STAFF REPORT
CITY OF BEVERLY HILLS

**For the Design Review Commission
Meeting of February 3, 2011**

TO: Design Review Commission
FROM: Shena Rojemann, Associate Planner
SUBJECT: A request for an R-1 Design Permit to allow a façade remodel of an existing two-story single-family residence, located in the Central Area of the City north of Santa Monica Boulevard at **724 North Elm Drive** (PL 103 8778).

Continued from the January 6, 2011 Design Review Commission meeting.

Proposed Elevation

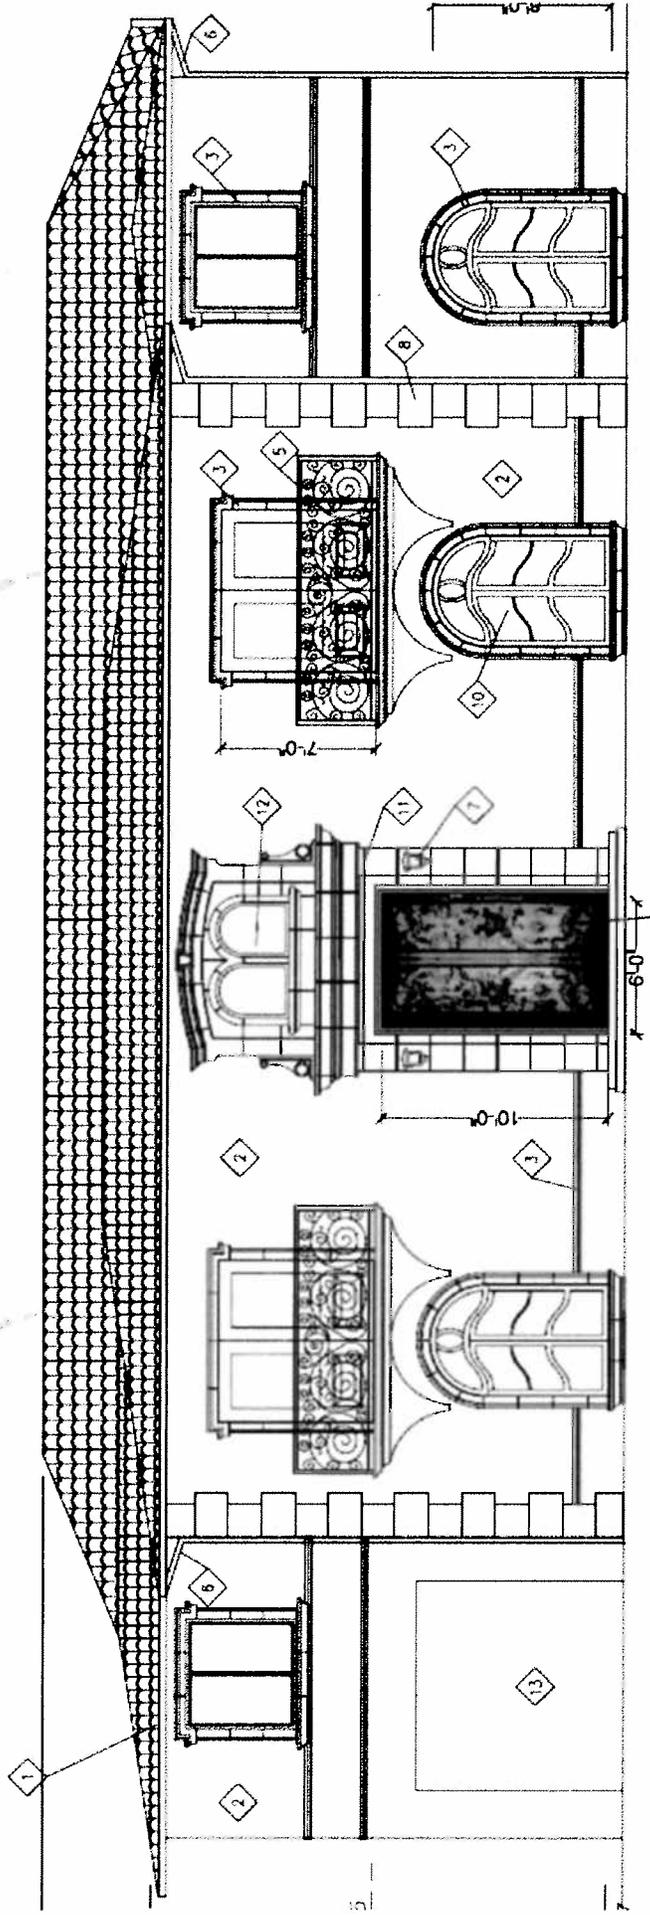
Design Review Commission Requests January 6, 2011 Meeting	Applicant's Response
1. The design elements do not complement each other (not an internally compatible design scheme).	1. The applicant has made changes to multiple element so the design in an effort to create a design that is internally compatible.

2. The proposed etched glass window is too modern and out of proportion with the other elements proposed.	2. The applicant has redesigned the windows above the entry. There are now two smaller windows which are encompassed by a precast concrete surround. This surround extends down to the ground floor elevation and encompasses the entry door as well.

3. The project is moving in the wrong direction.	3. The applicant has made design changes in an effort to create a design that is compatible between the old design and the new elements.

4. The scale of the windows, doors, and other design elements are off – there should be some consistency in scale and mass between elements.	4. The applicant is now proposing to maintain the overall design of the existing second story balconies, however a new railing design is proposed. The French doors at the second story have been redesigned and are now more squat than vertical in orientation. The windows along the second floor have been redesigned and are now wider, than taller. The precast concrete windows surrounds have also been redesigned. The ground floor French doors have been redesigned to be wider than taller.

5. The façade design feels clumsy and heavy.	5. The applicant has made changes to the massing and scale of the proposed façade elements in an effort to create a lighter, more elegant design.

6. The design does not improve the residence – it now feels intrusive.	6. The applicant has made changes to the massing and scale of the proposed façade elements in an effort to create a less intrusive design.

7. Consider updating the existing residence as opposed to redesigning.	7. The applicant is still proposing changes to the façade as opposed to updating the existing façade elements.

8. The details proposed (shorter balconies, taller windows/doors, removal of shutters, taller more enhanced entry) create a design with a vertical orientation. The horizontal orientation found in the existing design is of a more appropriate scale. As revised, the residence feels taller and does not minimize the appearance of scale and mass.	8. The applicant is now proposing to maintain the overall design of the existing second story balconies, however a new railing design is proposed. The French doors at the second story have been redesigned and are now more squat than vertical in orientation. The windows along the second floor have been redesigned and are now wider, than taller. The precast concrete windows surrounds have also been redesigned. The ground floor French doors have been redesigned to be wider than taller.

9. The development does not enhance the appearance of the neighborhood – the scale of the design is off, the design details do not complement each other.	9. The applicant has made changes to the design in an effort to create a design that enhances the appearance of the neighborhood.

10. The design does not take into the consideration the characteristics of the surrounding group of homes and fails to integrate appropriate features that will ensure harmony between old and new.	10. The applicant has made changes to the design in an effort to create a design that is in harmony with the old and new of the development of the surrounding group of homes.
---	--
